PLANNING AND DEVELOPMENT SERVICES STAFF REPORT

**SUBJECT: Ruth's Chris Site Plan for City Council Approval
(314 S. Fourth Avenue)
File No. SP14-010**

Design Review Board Comments

Design Review Board Comment Response

Proposed Ruth's Chris Steak House

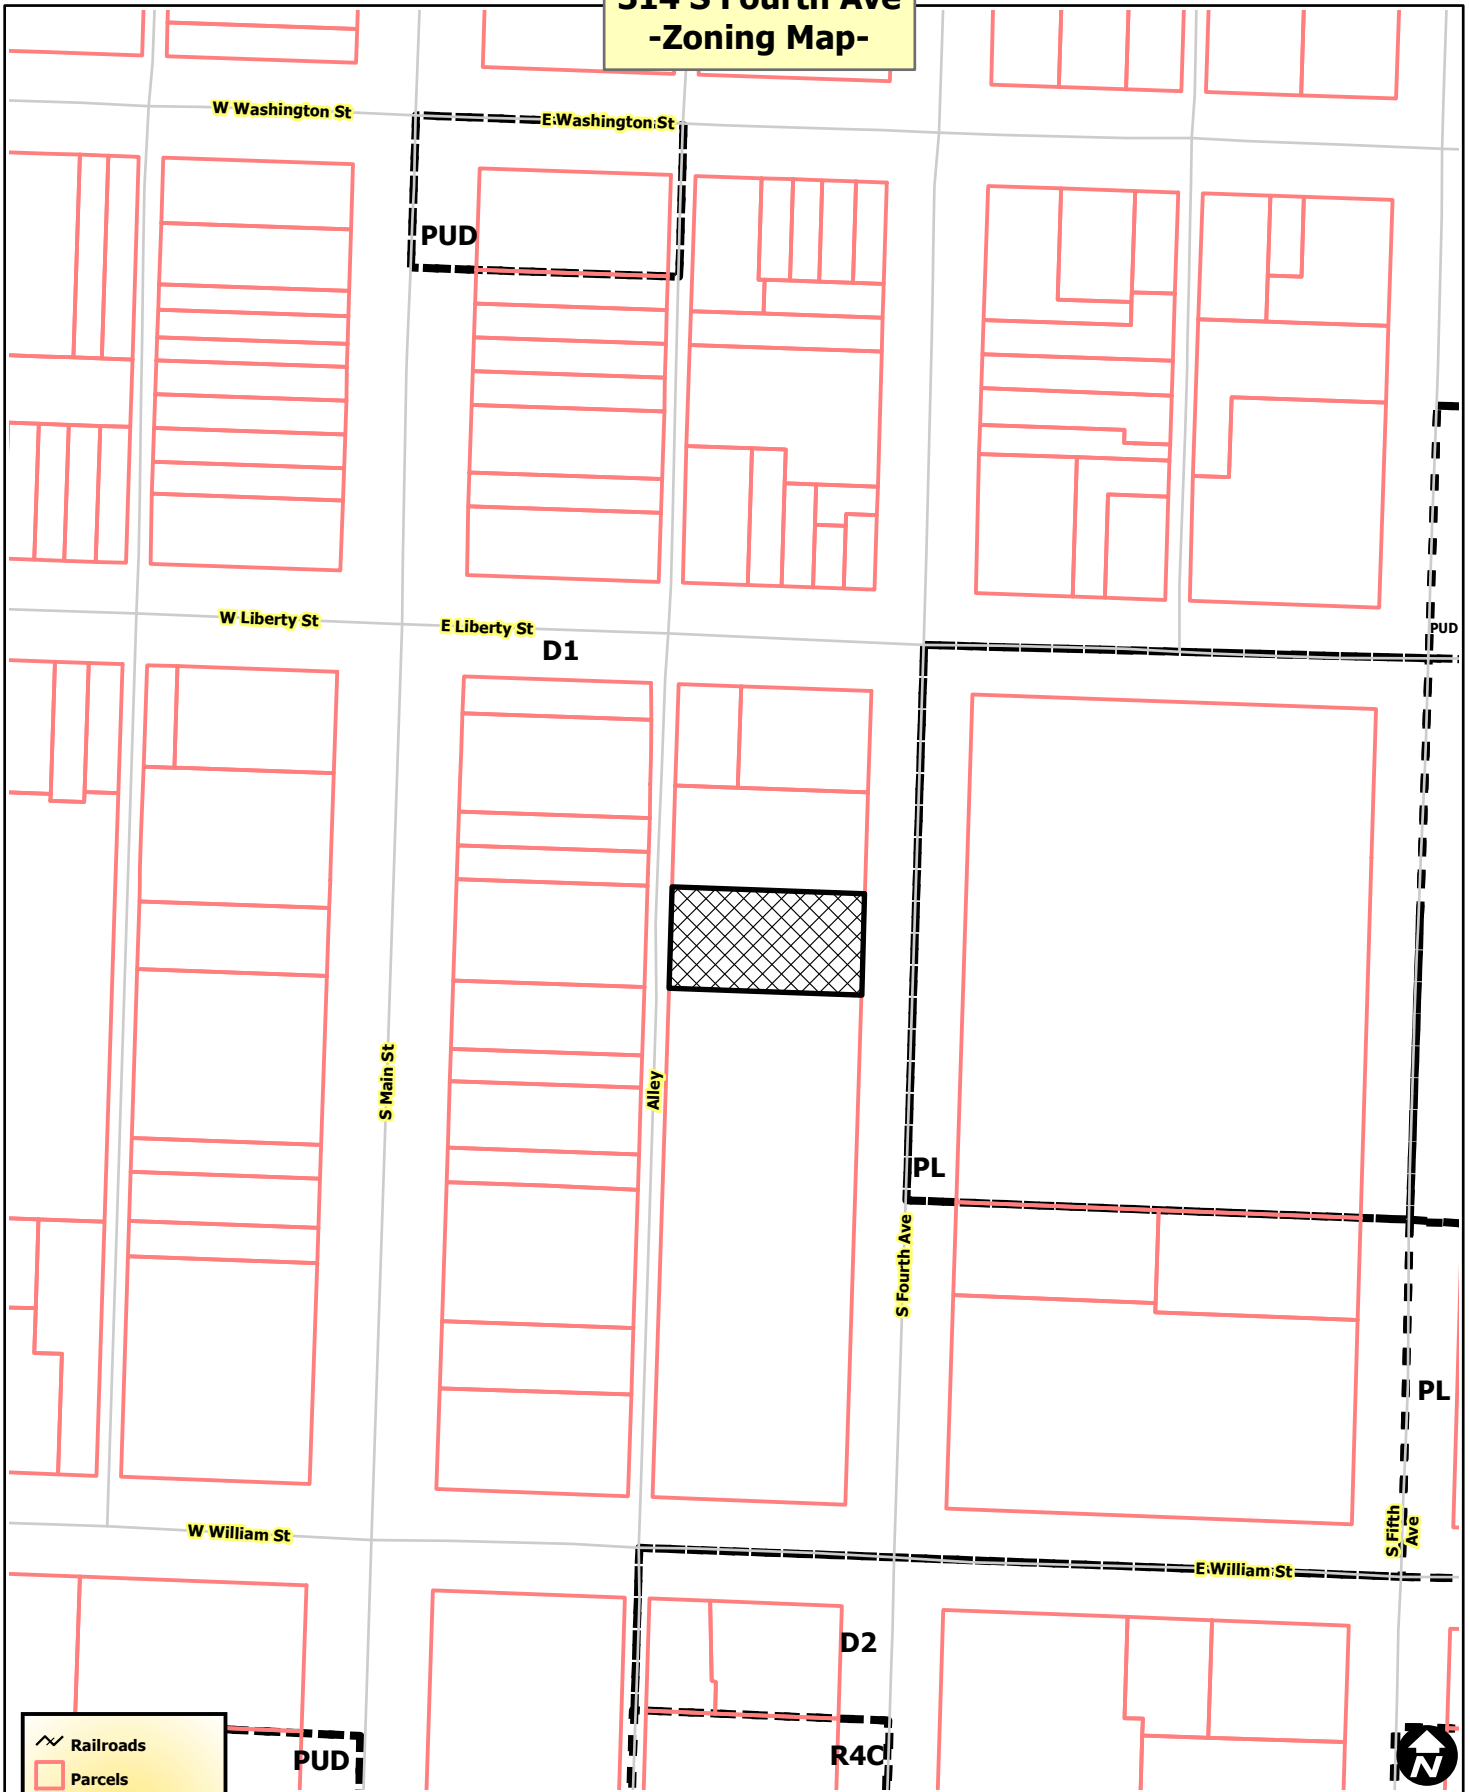
1. The proposed building and streetscape could and should do more to enhance the pedestrian experience. (A.1.1; A.1.2)
2. The proposed design does not currently add vibrancy to S. Fourth Avenue and could do more to create an inviting, pedestrian-oriented experience. (A.1.6)
3. There are potentials in the proposed design to add public art, lighting, and moveable windows to activate street life. (A.3.6; A.5.4)
4. Incorporate bicycle parking into the design or find ways to partner with existing bicycle parking facilities. (A.6.2)

1. The vertical elements on the building façade are appropriate to the scale of neighboring buildings, but at a cost to pedestrian scale for those walking on the west side of Fourth Avenue. Try to more effectively balance the two. (B.1.3)

1. Use building elements that invite pedestrian activity. (C.1.1)
2. The proposed materials (EIFS, ashlar masonry, metal panels, and spandrel glass) relate more closely to outlying areas such as Briarwood or East Washtenaw Avenue than downtown Ann Arbor. Consider alternatives. (C.1.1)
3. Try to design the mezzanine windows so that they reference established patterns of nearby buildings. Reconsider symmetrical north and south bays.(C. 3.2)
4. Consider operable windows for natural ventilation at east wall of north bay to connect the lounge area to the street. (C.7.3)

The Board expressed concern that the building “turns its back” on Ann Arbor and encouraged the petitioner to consider frontage and streetscape design alterations that activated pedestrian activity on the street. The Board acknowledged the difficulties of the street such as the bus station, parking garage and post office, as well as the restaurant’s need to represent the brand.

Several of the Board's comments revolved around doing more with the streetscape, suggesting landscaping, seating, public art, lighting (provided) and perhaps water features. The reality is that this is a zero lot line existing building and the sidewalk is owned by the City. We have discussed the need for streetscape improvements in this area with the DDA and welcome such future improvements.

The Board also suggested adding sidewalk seating and opening windows on the first floor level. The building faces east (no sun) and this restaurant plans to open for dinner only. In addition, this section of Fourth Avenue has heavy bus and vehicular traffic at fairly high speeds and limited sidewalk area. While we did consider these options, we concluded that in order to guarantee the type of dining experience that our customers expect, we needed to provide a protected environment free from unwanted noise and odors. The entire first floor will be clear windows to maximize pedestrian visibility. Plans also include a staffed valet service during hours of operation which will also provide increased activity and vibrancy to the streetscape.

The first exhibit shows the existing building façade. The second exhibit shows our proposed elevation side-by-side with a sample photo taken directly from the Midtown Character District Downtown Design Guidelines. I think these images are very similar with our proposed façade being slightly more modern and updated.
